December 29, 2021

Re: **Petition No. 1470 – Petition for a Declaratory Ruling on the Need to Obtain a Siting Council Certificate for the Installation of a Temporary Telecommunications Facility at Sacred Heart University, 5151 Park Avenue, Fairfield, Connecticut**

# PLATTSVILLE RELO CT

SHEET NUMBER  
**C-2**

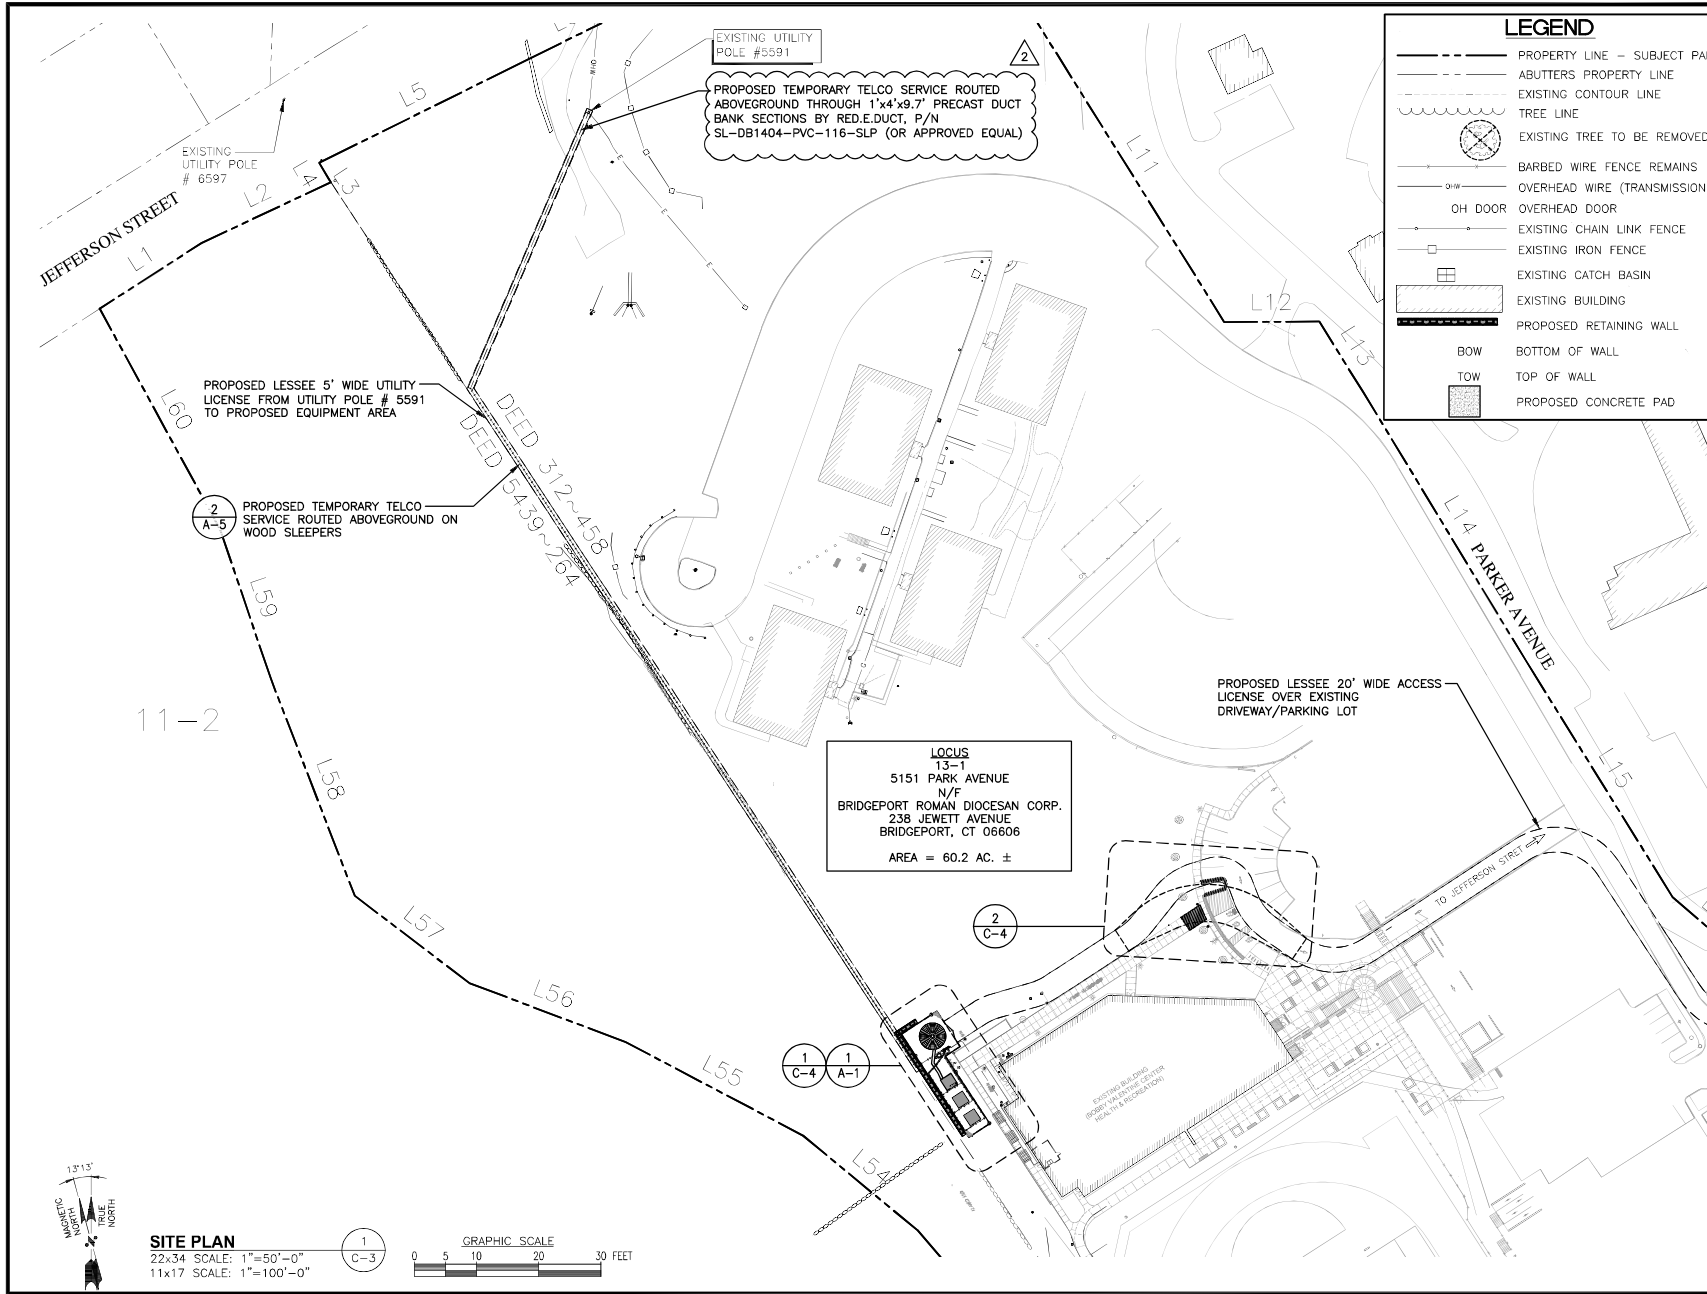
1. Cellco has decided use existing Utility Pole No. 5591 near the Sacred Heart University (“SHU”) maintenance facility for the temporary installation of telco (fiber) service to the approved temporary tower site on the SHU Main Campus. The use of this existing pole will eliminate the need to install a new utility pole within the Jefferson Street right-of-way which would require additional regulatory approvals.

SHEET NUMBER  
**C-4**

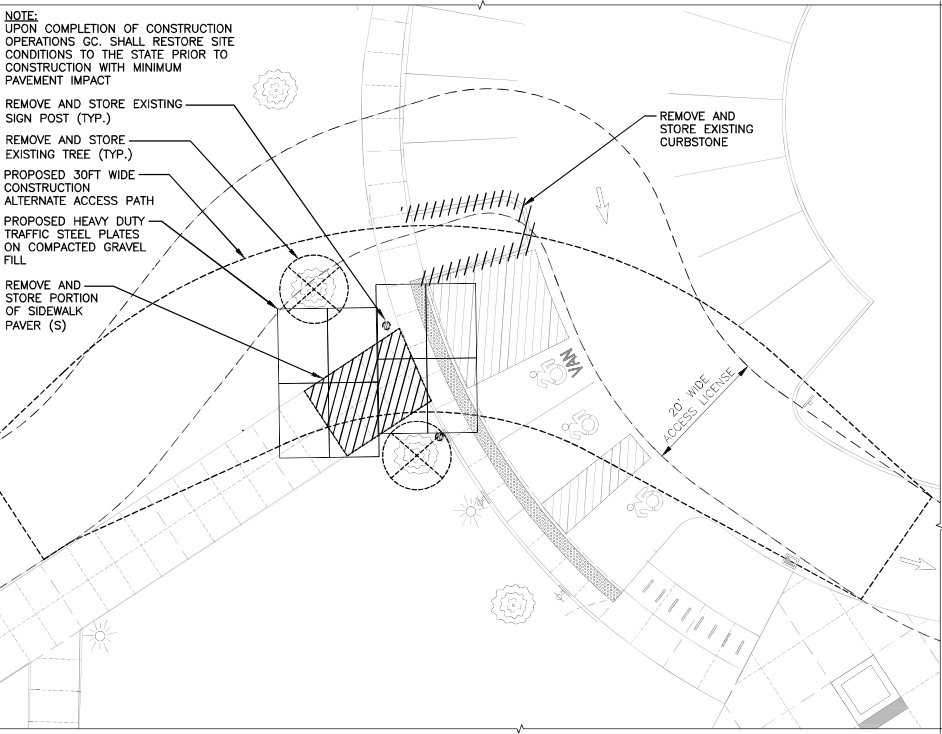
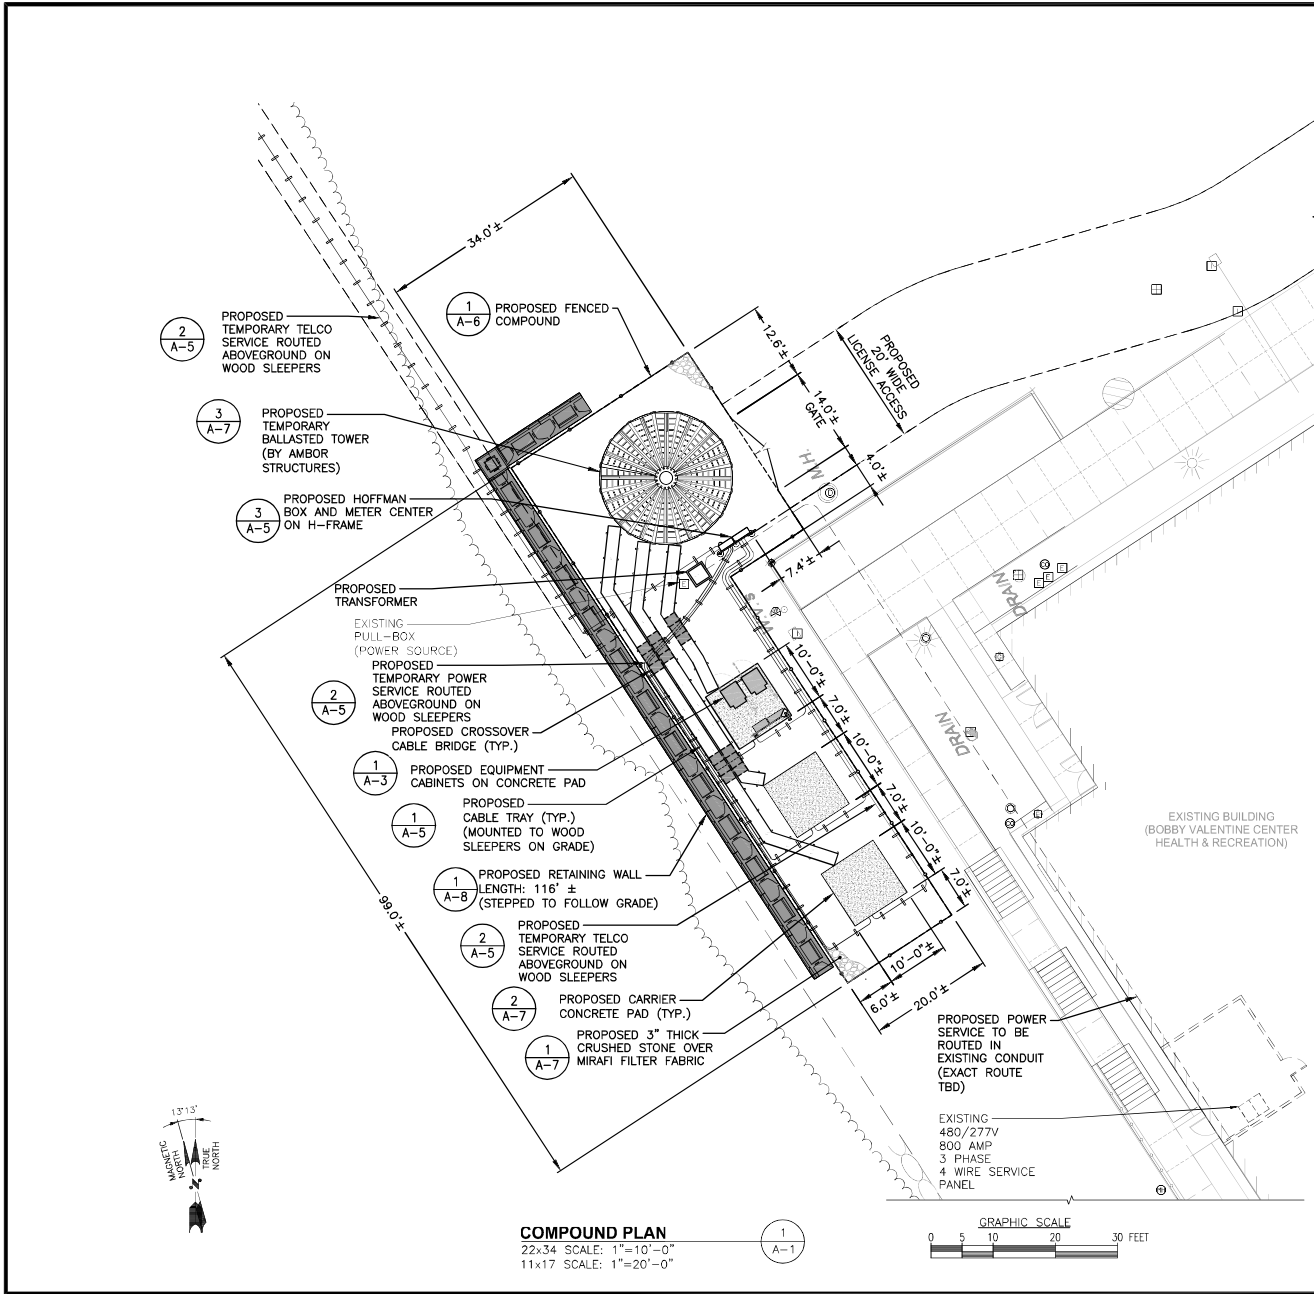
2. Due to development restrictions in place on the wooded parcel to the west of the approved temporary tower site, Cellco’s engineers have had to redesign the retaining wall included on the project plans. The tallest portion of the retaining wall shown on the approved plan was five feet above grade at the northern end of the wall. (*See Cellco’s Response to Council Interrogatory No. 4*). Upon further review of existing site grades, it was determined that

a retaining wall, as originally approved, would have required additional site grading to extend onto the adjacent wooded parcel to the west. To eliminate this grading onto the adjacent wooded parcel, which is prohibited by the existing development restrictions, the height of the northerly corner of the retaining wall will need to increase to ten feet above grade. The wall will taper down from ten feet to one-foot above grade near the temporary tower site and two feet above grade at the southern end of the wall.
